AGENDA
FARRAGUT MUNICIPAL PLANNING COMMISSION

January 18, 2018
7:00 p.m. Farragut Town Hall

REPORT TO THE FARRAGUT MUNICIPAL PLANNING COMMISSION

SUBJECT: Discussion and public hearing on a request for approval of a resubdivision plat to remove the Finished Floor Elevation (FFE) and relocate the 50-foot building setback buffer, as measured from the sinkhole lip elevation, for Lot 60 in Unit 3 of the Sheffield Subdivision, .267 Acres, Zoned R-1/OSR (Ryan Lynch, Applicant)

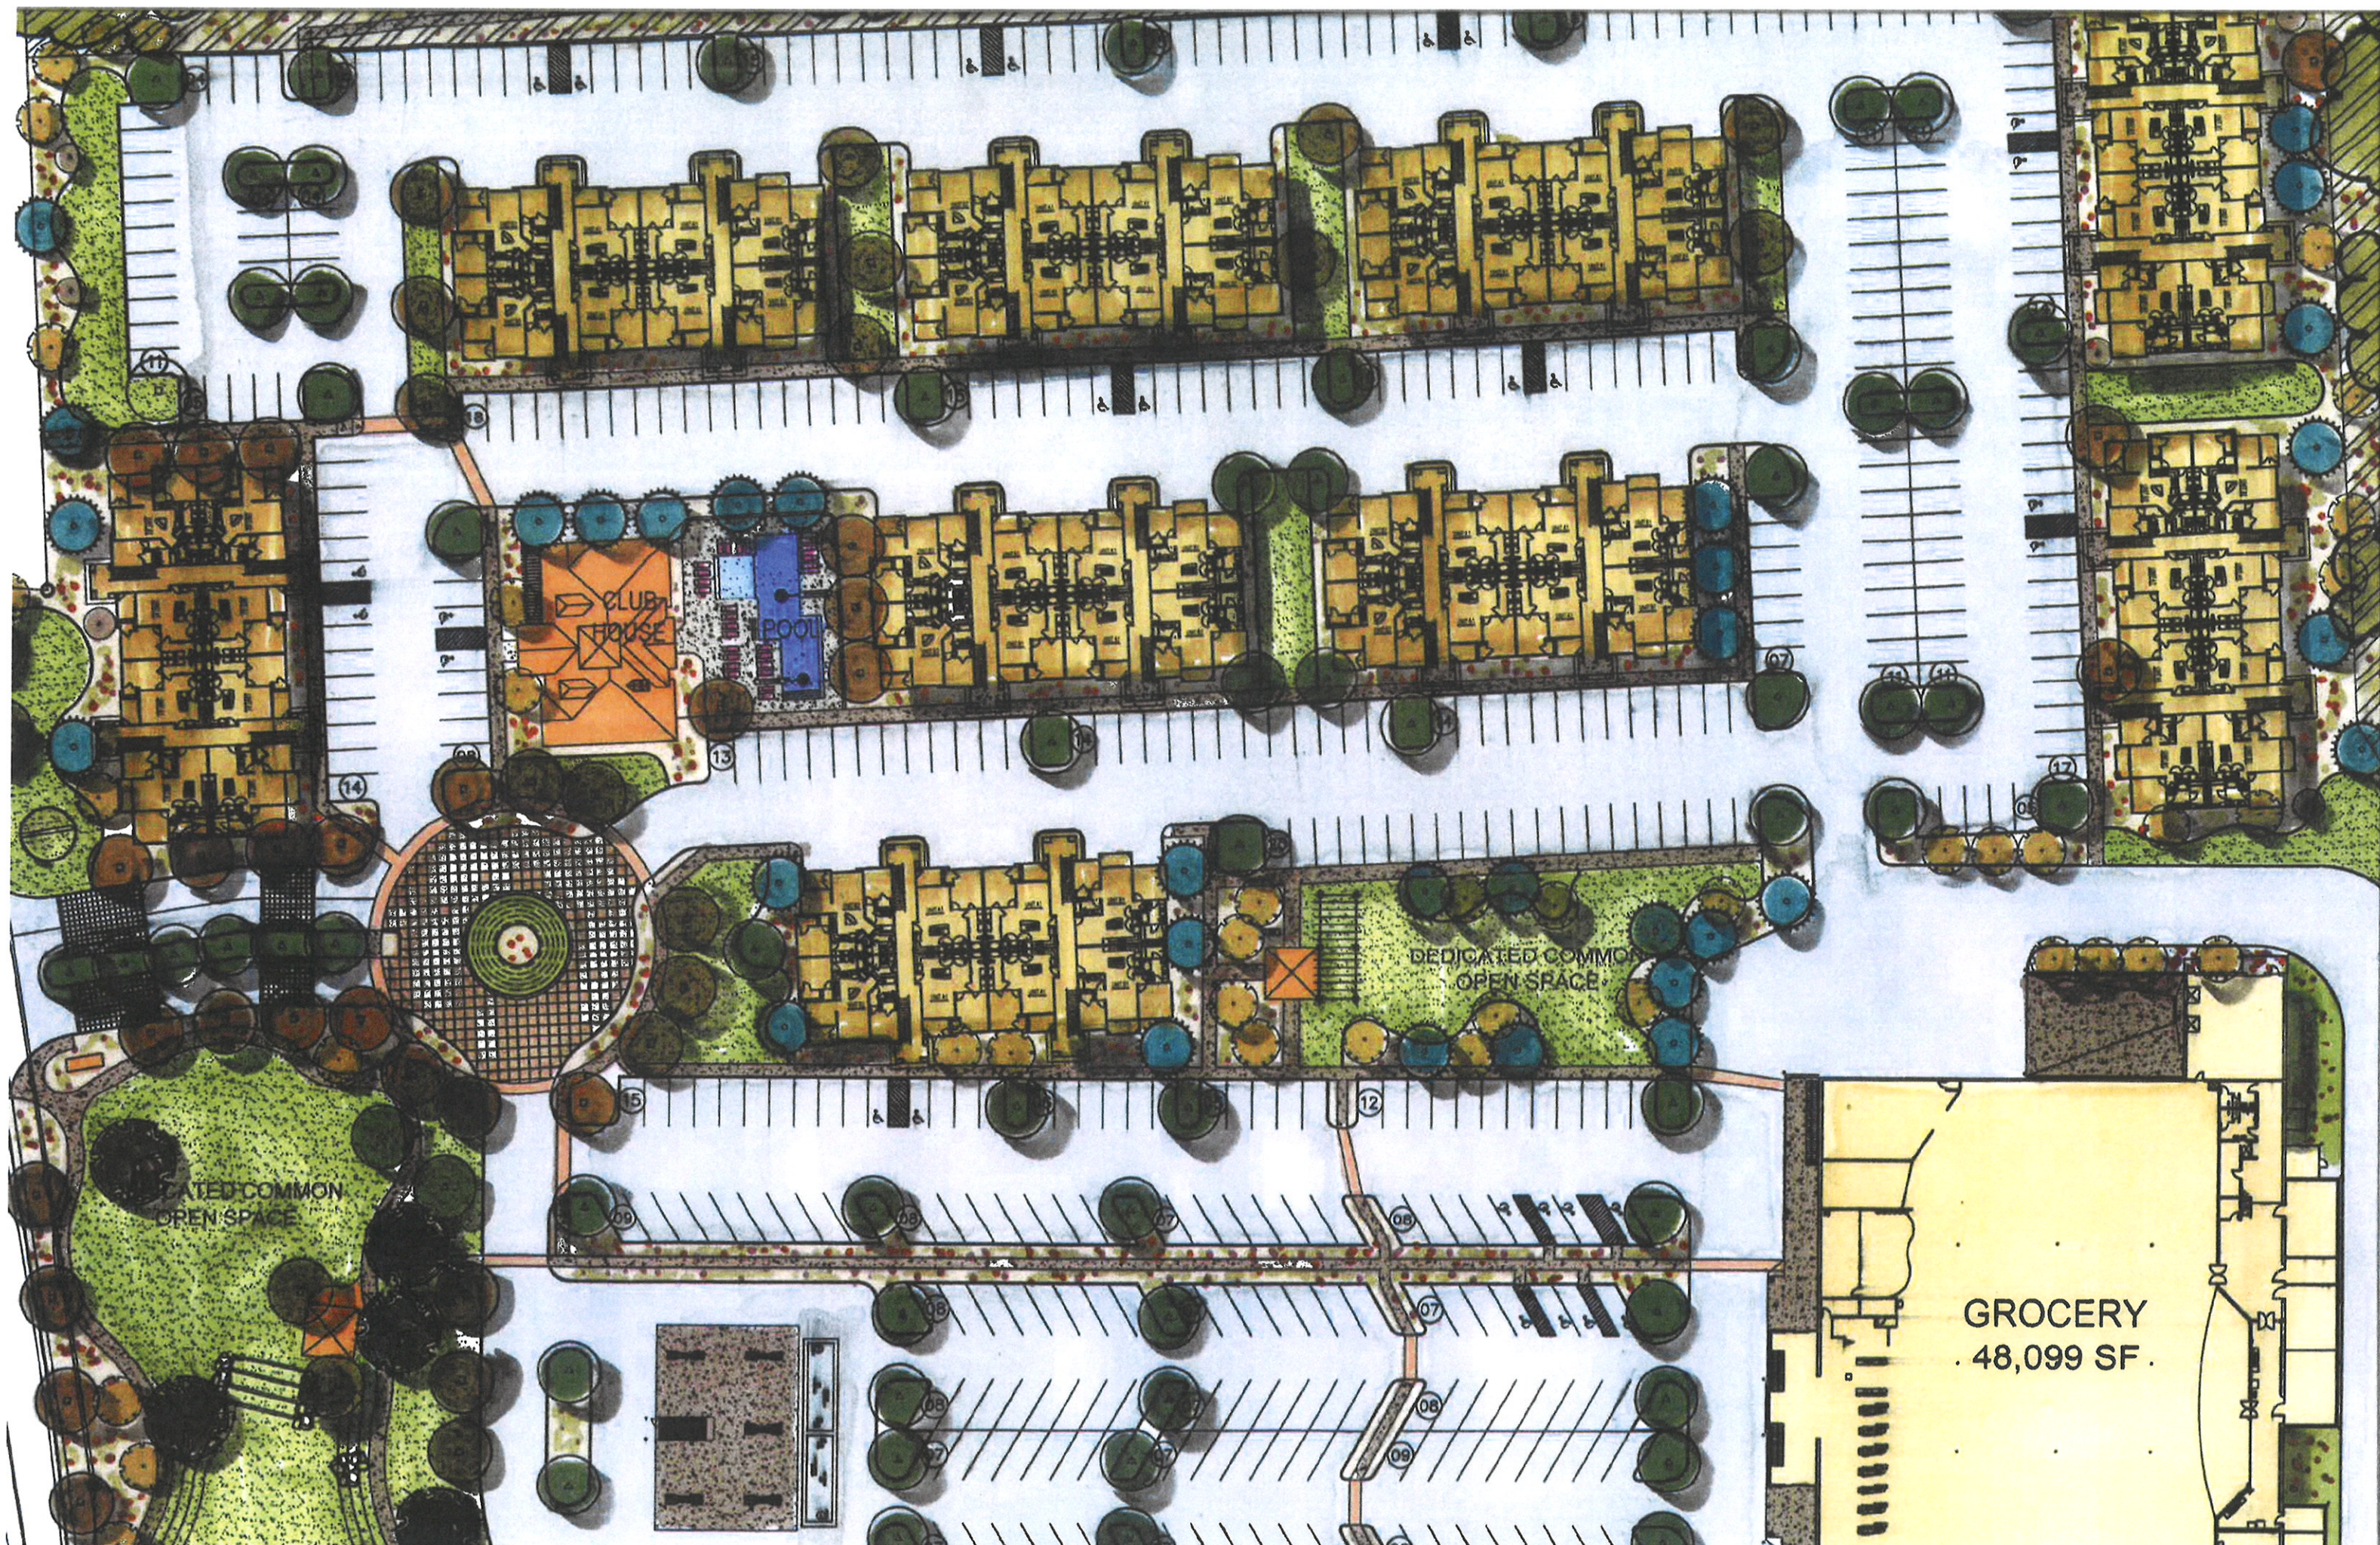
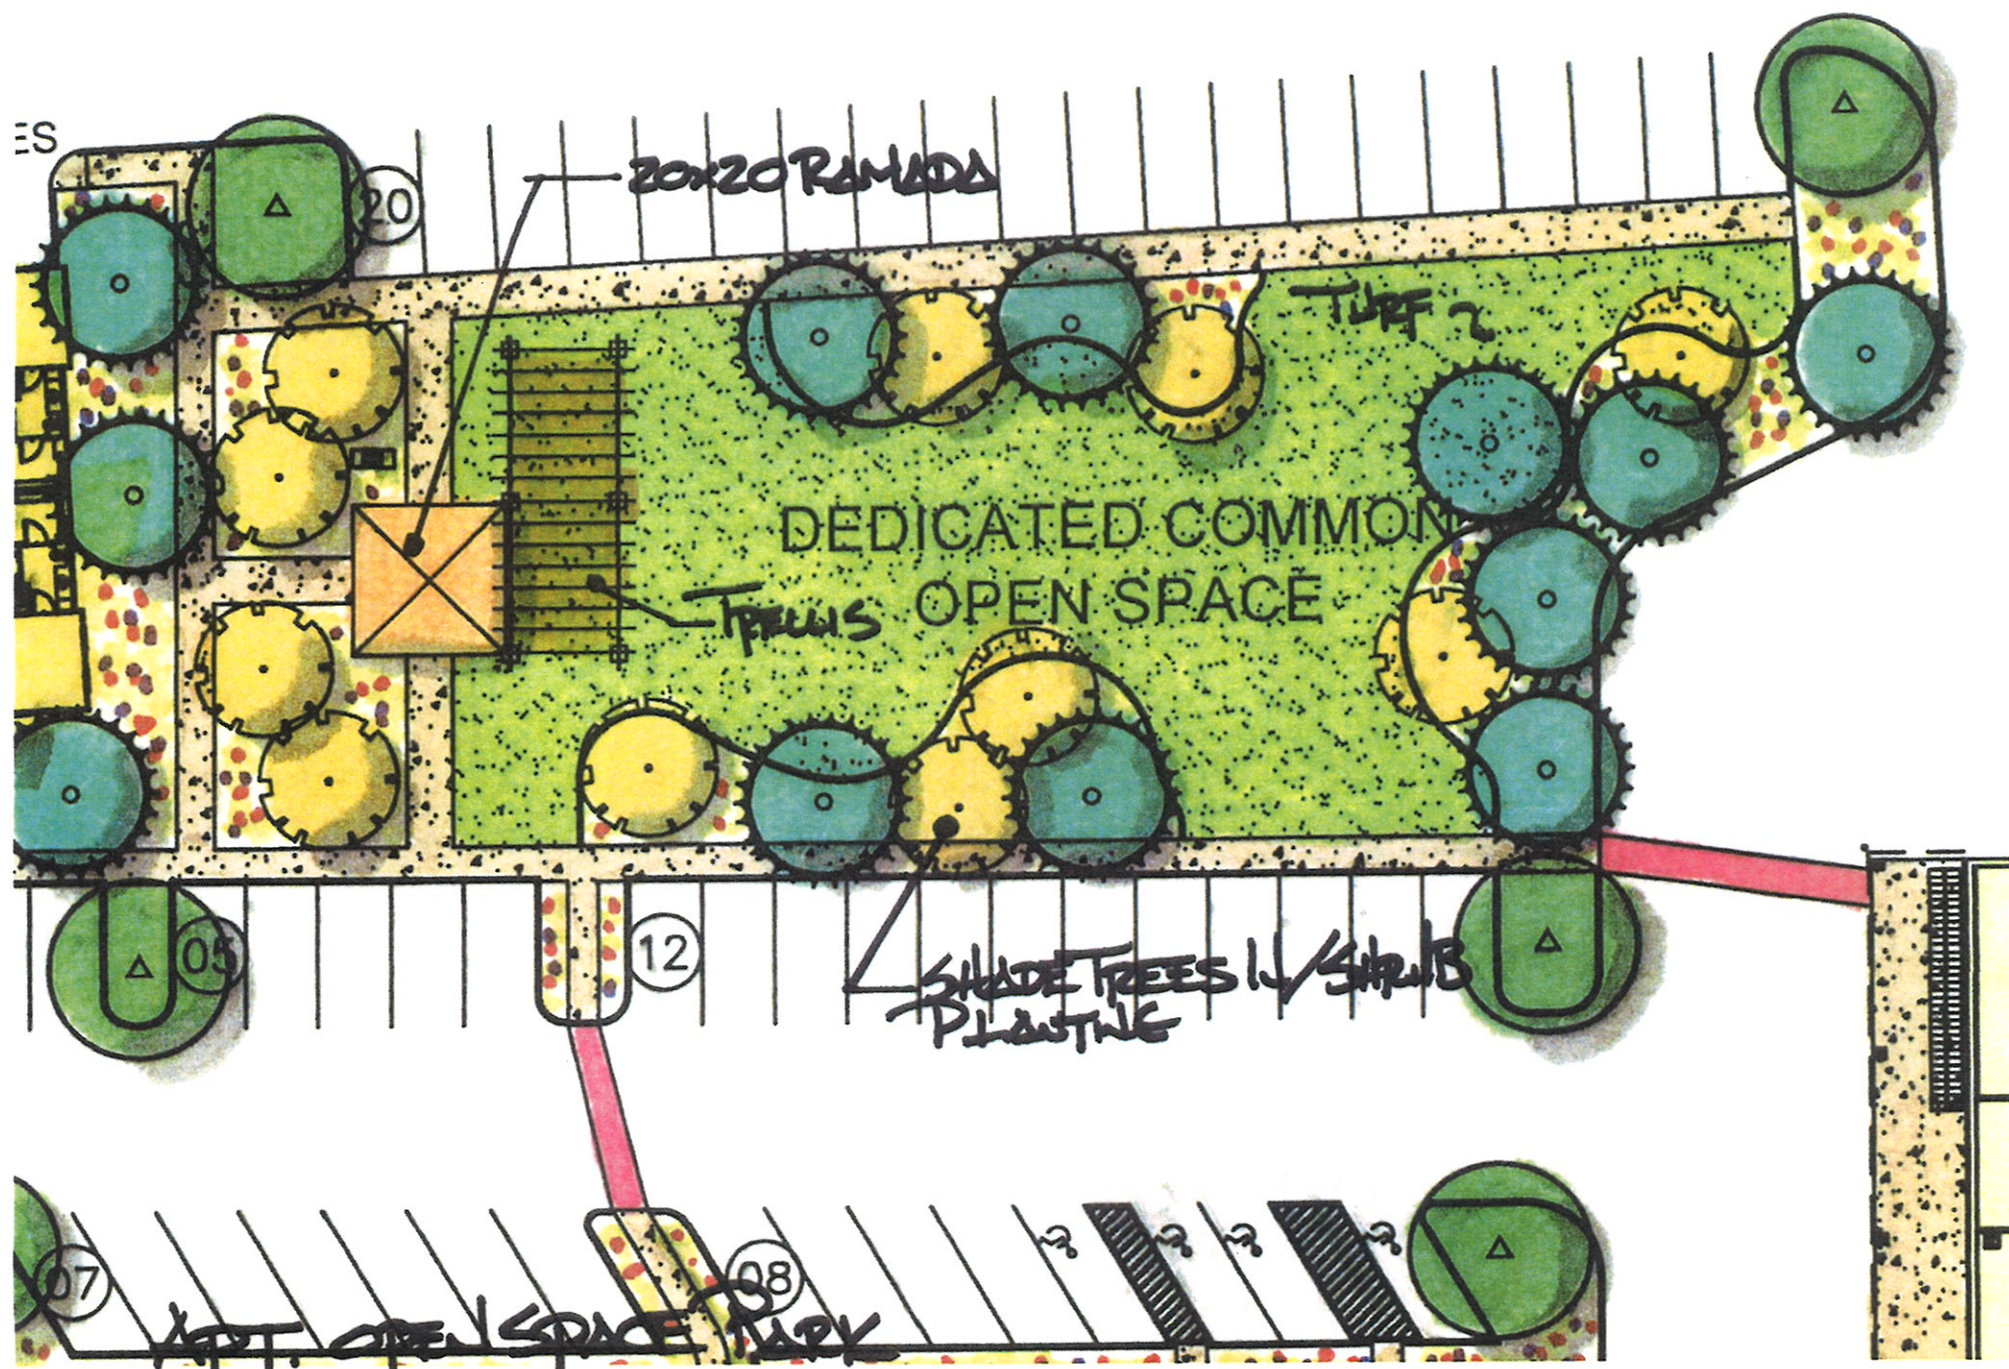
- 2) The plan does not adequately address vehicular and pedestrian connectivity to abutting properties.
 - a) There are no planned connections to the west, particularly to the commercially zoned properties in Loudon County. The planning commission should consider the need for such connections and what type of provisions the developer should make for them.

- b) Pedestrian connectivity between the proposed development and the Little Joe's site should be better defined and enhanced. This should be coordinated with any design changes related to the previously discussed access point on Kingston Pike.

- c) The Town's staff questions the utility of the proposed pedestrian access to the south (at the top of the hill) and the impact of its construction on a required transition and buffer area.

- 3) Improvements to the site's internal pedestrian circulation and landscaping plan areas should be considered. Additional sidewalks are needed to facilitate pedestrian movement in several areas; including but not limited to; from the western most apartment building to the rest of the site, along both sides of all buildings adjoining parking areas, and along the south side of the main entrance to S. Watt Road. All sidewalks and connection points between areas within the overall site should also be ADA compliant and fully accessible. Additional landscaping areas should be provided at the front of the proposed supermarket building. The project is being developed as a PCD and design elements, including landscaping, should exceed those found in a typical development.

- 4) The Town's staff continues to question whether the proposed "open space" areas satisfy the PCD ordinance's objectives of "functional common spaces, ... located to provide focal points to be actively used." The submitted site plans provide additional grading information that was not available as part of the concept plan, including the use of significant retaining walls. The plans do not clearly identify the height of these walls, but during the staff developer conference it was noted that they range as high as thirty (30) feet in places. The identified open space behind the apartment's is isolated and of little use to the residents due to the grade and retaining walls. In addition, the open space area located closest to the grocery store is also separated from the apartments by grade and a retaining wall. This results in a situation where the planned "functional open space" consists of largely inaccessible open space areas behind the apartments; an area close the grocery's loading dock that is located below and largely separated from the apartments, a walking path around the detention area adjacent to the fuel pumps, and the apartment's clubhouse and pool. The planning commission will need to determine if this is adequate or if design changes need to be made.

- 5) The developer has not clearly identified the environmentally sensitive areas on the site. This includes but is not limited to; steep slopes, wet-weather conveyances, and wetlands. The protection of natural resources is an objective of the PCD zone. Unfortunately, the site is essentially being mass graded to accommodate a desired amount of development in three largely grade separated areas. This in turn, seems to be influencing other site design elements including; functional open spaces, pedestrian and vehicular circulation, and building arrangement. Staff acknowledges that the site's topography will involve grading and impact design, however, it appears that the desired development is simply being imposed on the site.
